ACT Heritage Council

Statement of Heritage Effect Approval

Applicant Reference: 23 Dirrawan Gardens
Heritage Reference: Reid 5-28
Contact Officer: Kate Harrison
Received by Council: 17 May 2015

Block:	Section:	Division / District:	Heritage Place:
5	28	Reid	Reid Housing Precinct

BLOCK 5	SECTION 28	SUBURB REID	SCALE	1:200 @ A3
DRAWING	SITE PLAN		DRAWN	RJ
PROJECT	PROPOSED NEW RESIDENCE		PRINT DATE	17/01/2019
CLIENT	RESIDENCE		PROJ No.	1809
			REVISION	
			DWG No	SP02

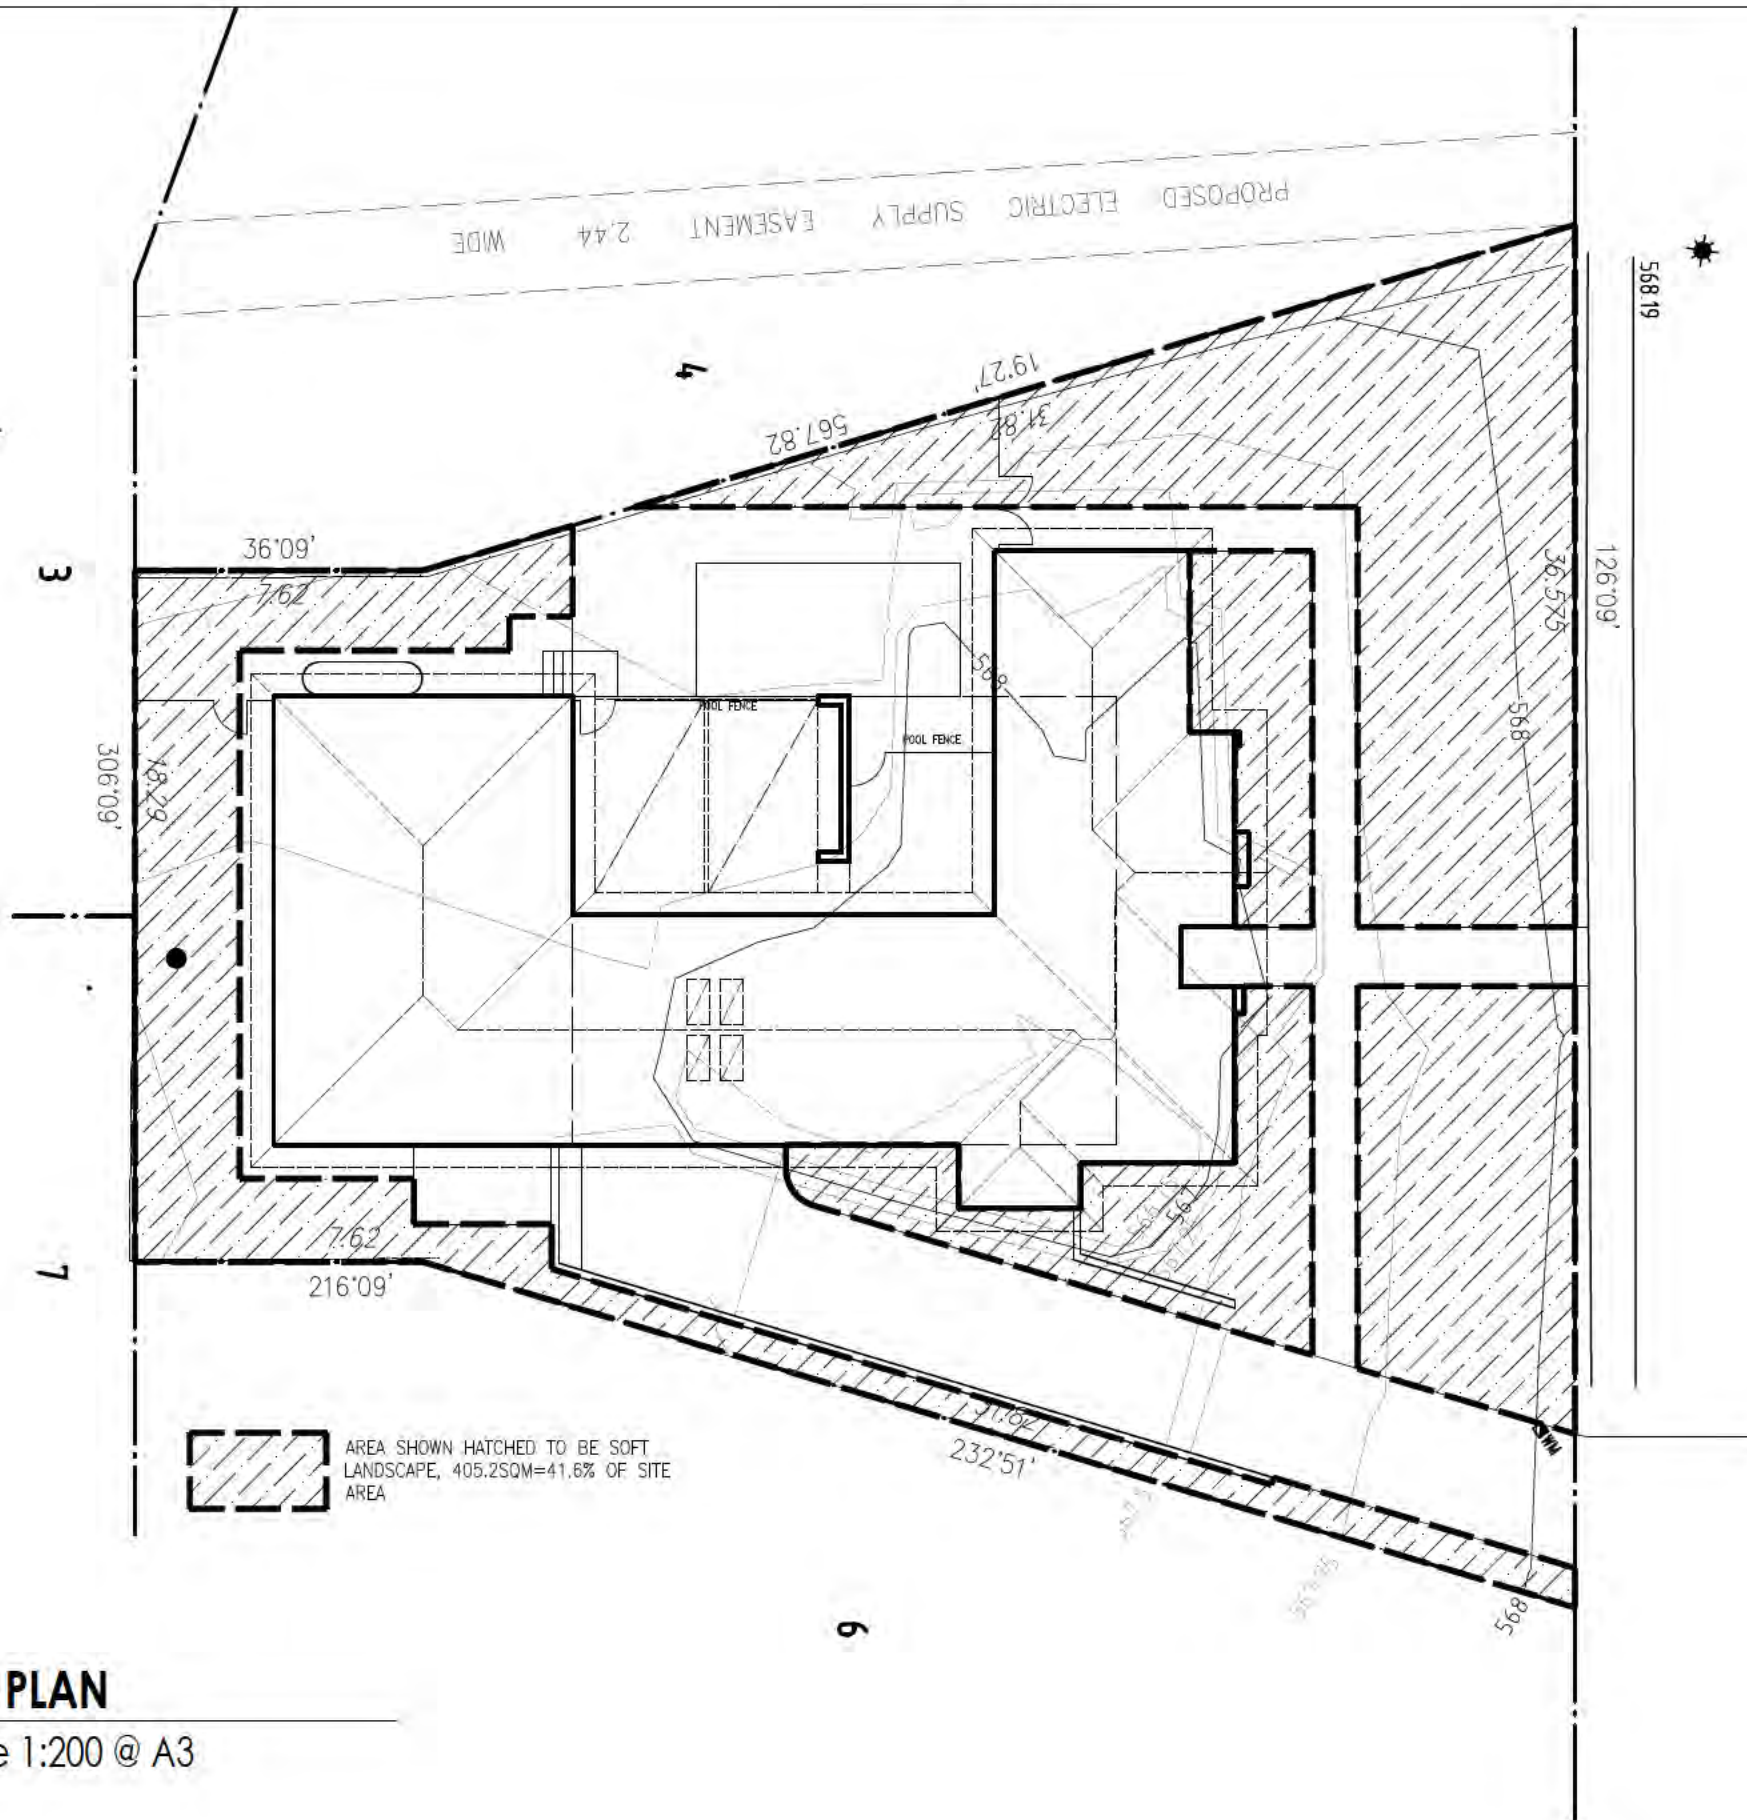
3. In the absence of a detailed Landscape Plan for the block, clarification of the extent of any proposed hard surfacing is required to ensure that a minimum of 40% of the area of the block is retained as planting area in accordance with **Mandatory Requirement 2.1e** of the Guidelines. **I have provided a diagram showing soft landscape hatched (SP02)**

BLOCK	5	DRAWING	ELEVATIONS	DRAWN	RJ
SECTION	28	PROJECT	PROPOSED NEW RESIDENCE	REVISION	
SUBURB	REID	CLIENT	RESIDENCE	REVISION DATE	
SCALE	1:100 @ A2			JOB No:	1809
				PRINT DATE	06/03/2019
				DWG No:	BA06

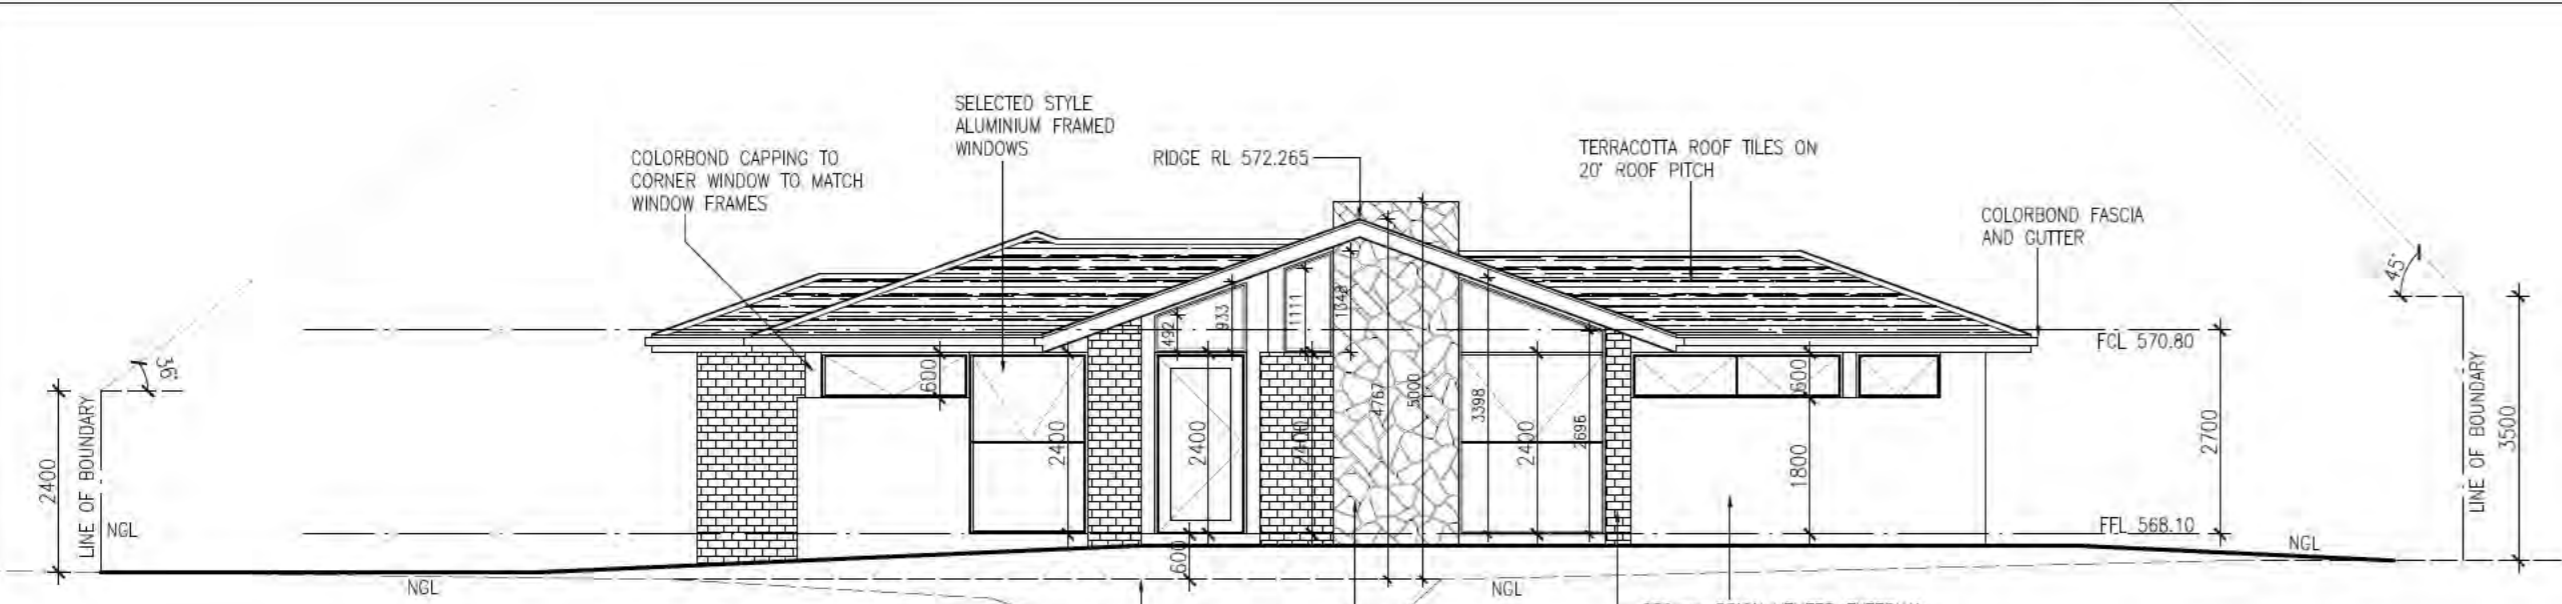
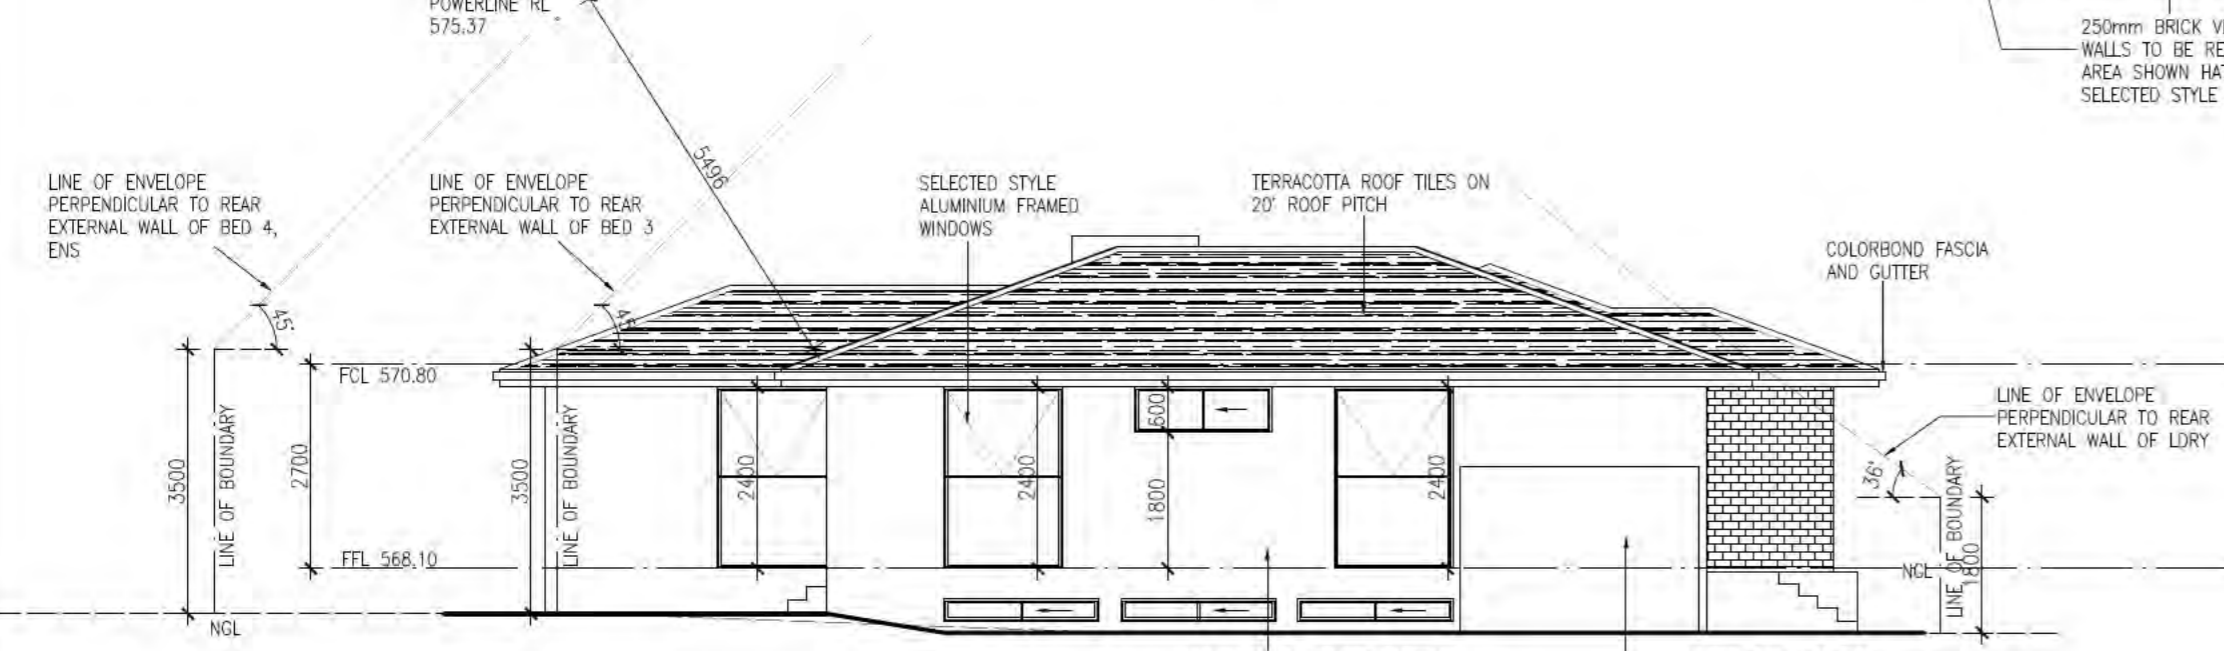
- A reduction of site coverage to comply with Mandatory Requirement 2.1d;
- Revised elevations that demonstrate that the RL of the new dwelling is not higher than adjacent dwellings; and
- Revision of the dark roof tiles to a natural terracotta colour tile.

Council notes that the revised submission identifies the RL of the adjacent dwellings as 573.85 and 572.95. At 572.26 the RL of the proposed new dwelling is not greater than the existing adjacent dwellings and is consistent with previous Council advice.

SITE PLAN
Scale 1:150 @ A3

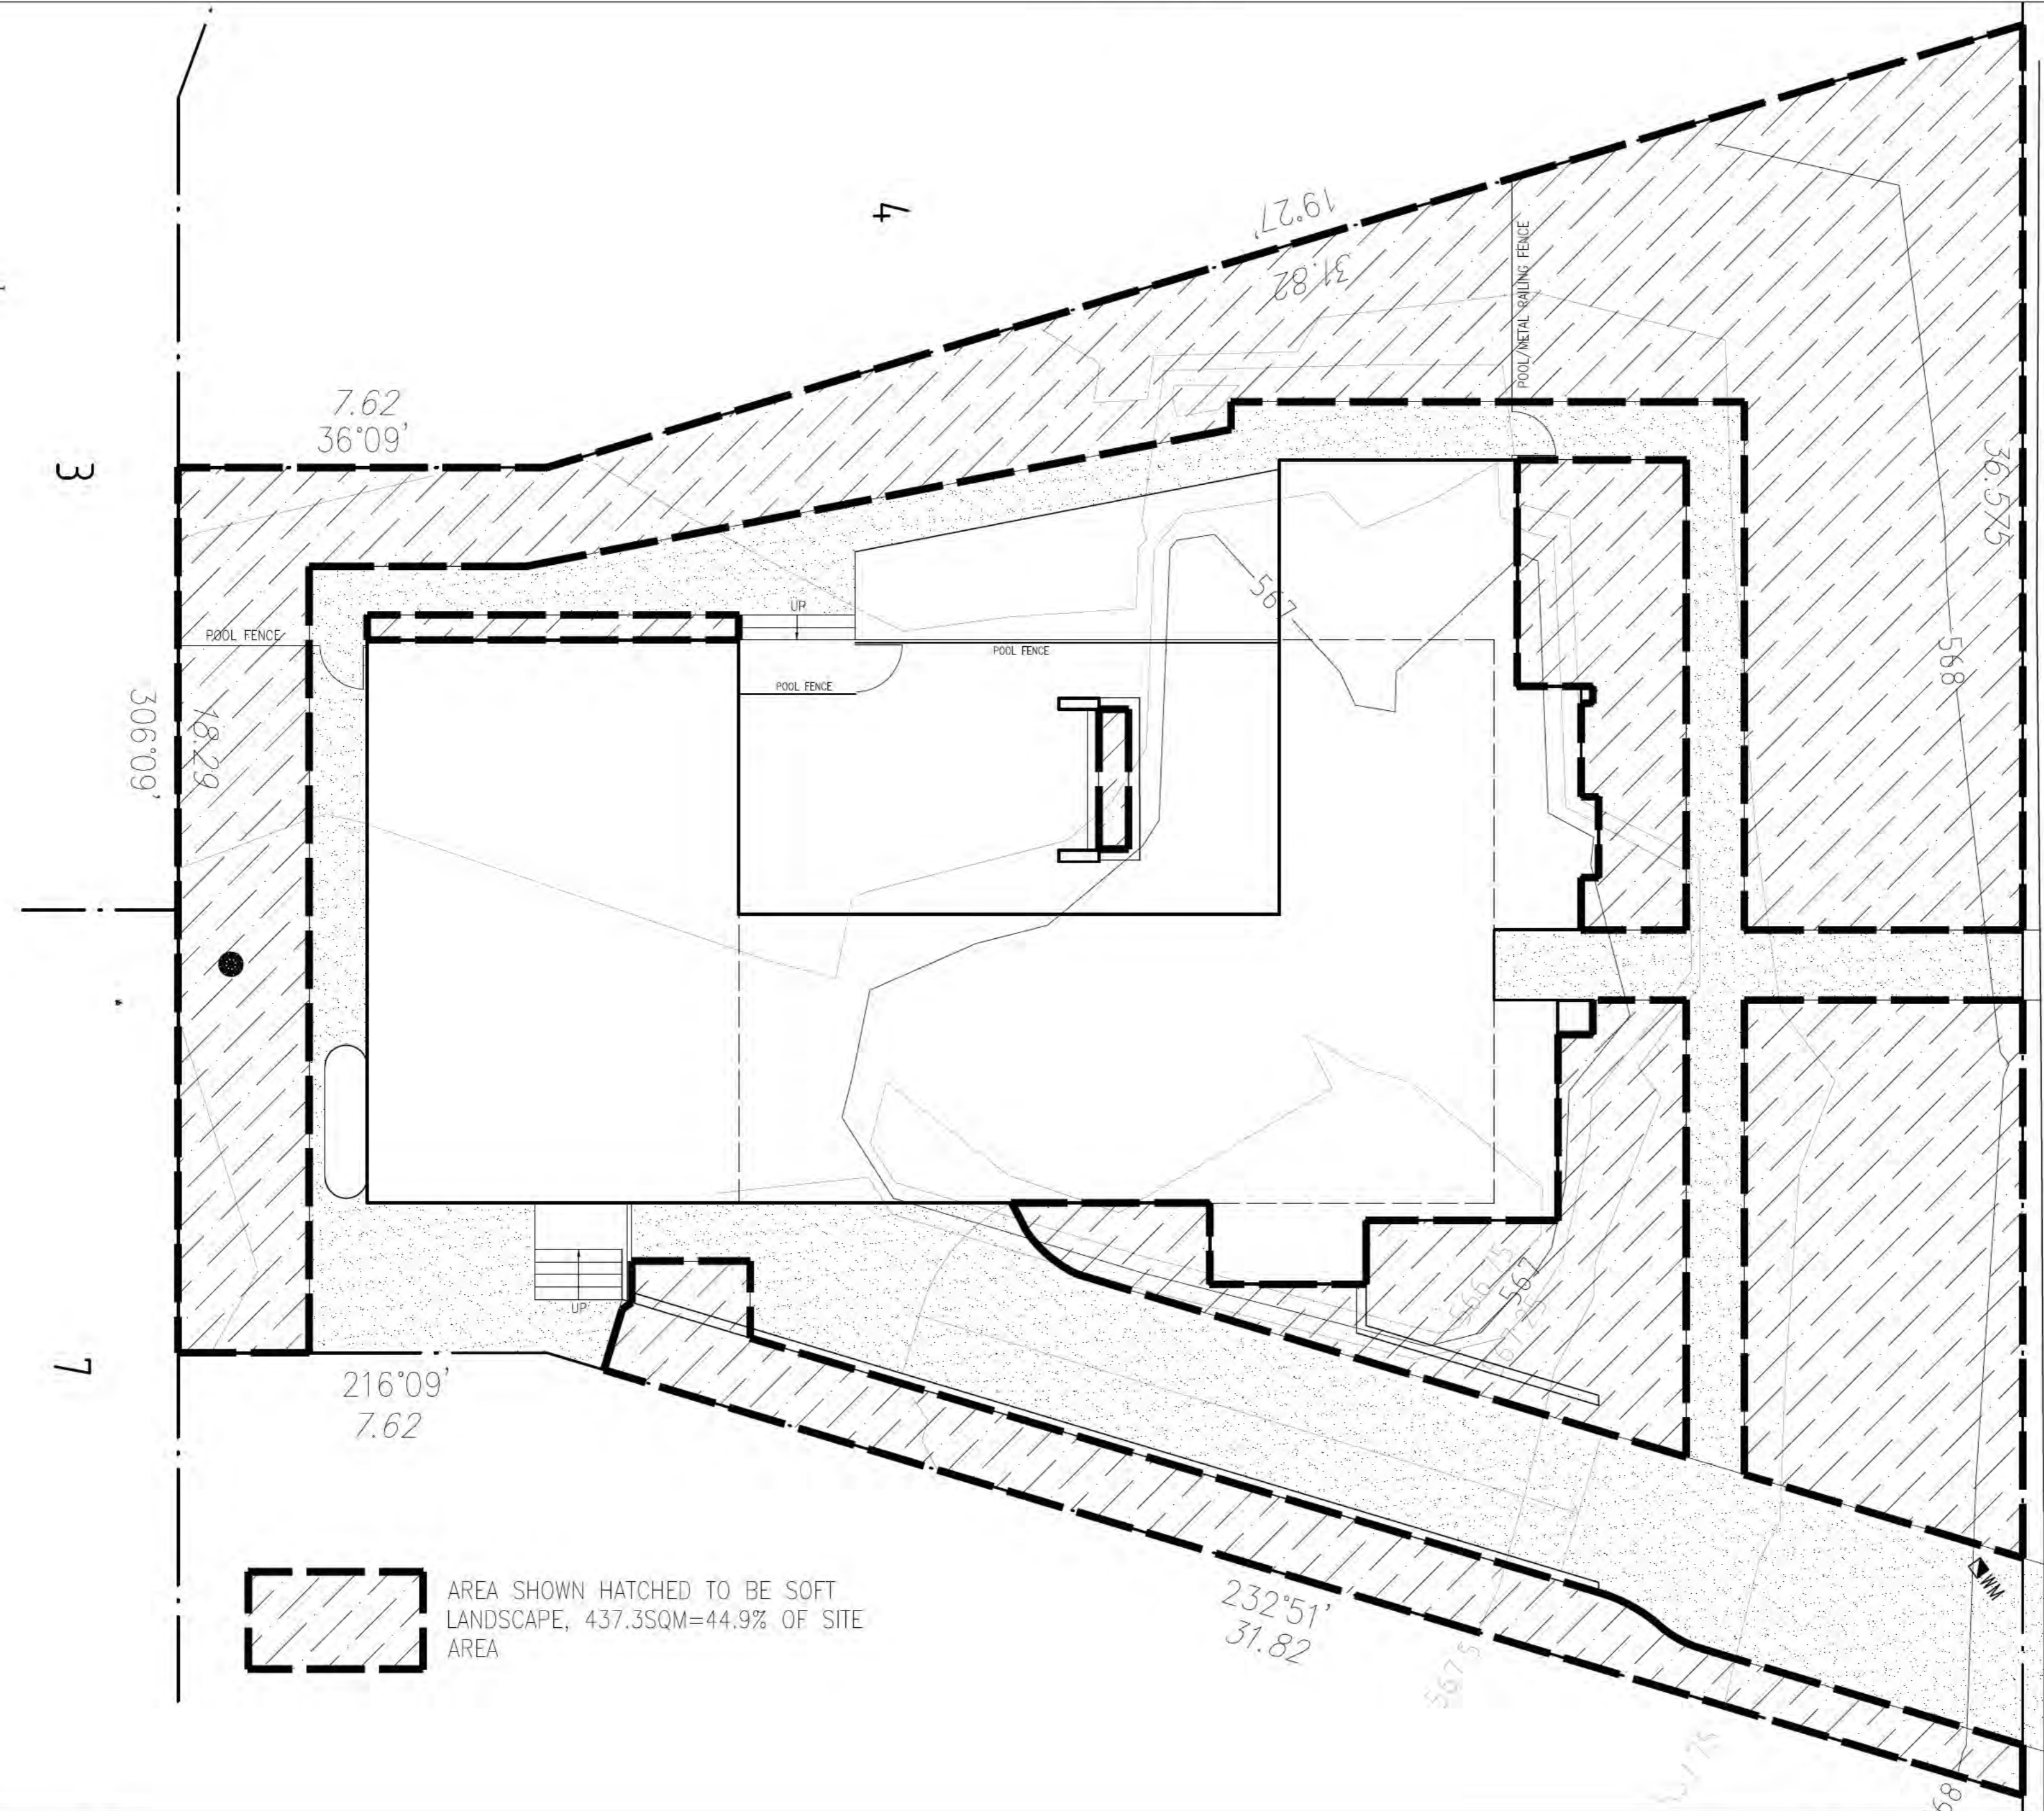
The intention to retain 41% of the area of the block for soft landscaping is consistent with Mandatory Requirement 2.1 (e) of the Guidelines for the Precinct. However, a detailed Landscape Plan has not been provided which identifies existing plantings, any proposed removals and future planting intentions for the block.

To demonstrate compliance with these requirements, a detailed Landscape Plan is required, which also shows the proposed removal of any trees or shrubs over 6 metres tall.

AREA SHOWN HATCHED TO BE SOFT LANDSCAPE, 437.3SQM=44.9% OF SITE AREA
